Native/Pierre Inspection Problem Abatement Photos

May 13, 2024

This letter is to address three of the required corrective actions stemming from the Native/Pierre Mine inspection conducted on March 13, 2024. The report for this inspection was signed and received on April 11, 2024. This letter will address those correction action items that have a due date of May 13, 2024 per the inspection report.

Photo of closeup of brick backfill material at bottom

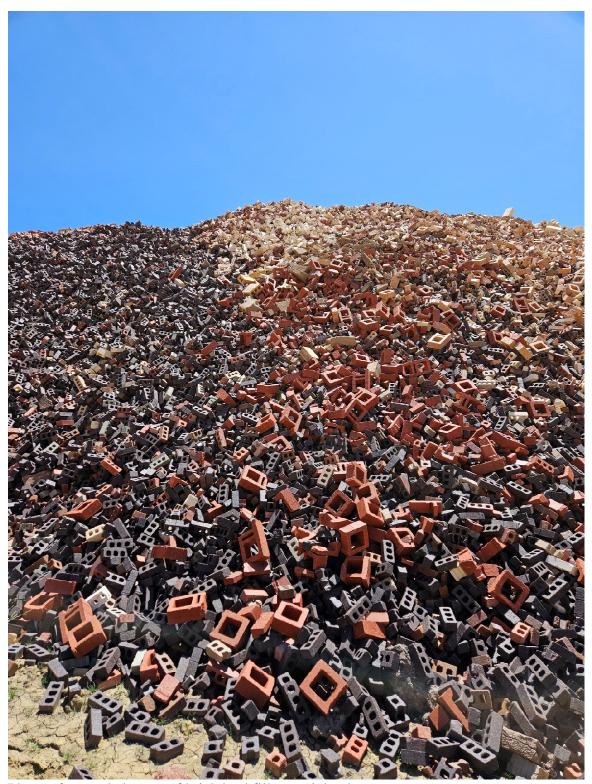
PROBLEM: Trees, wooden pallets, plastic wrap, and plastic banding were mixed in with the approved discarded brick backfilling material. These items are not inert materials per Rule 1.1(22) and the incorporation of them with backfill material does not comply with Rule 3.1.5(9).

CORRECTIVE ACTIONS: The operator shall remove these mediums from the discarded brick backfilling material and provide photos that the material has been removed.

CORRECTIVE ACTION COMPLETED: Non-inert material was removed from the brick backfill, including from the top, bottom, and slope. Additionally, plant workers were trained to not use the bins where brick is discarded during the manufacturing process to discard any other type of trash. Ongoing maintenance will be completed to ensure non-inert materials are not present in the brick backfilling material at the mine.
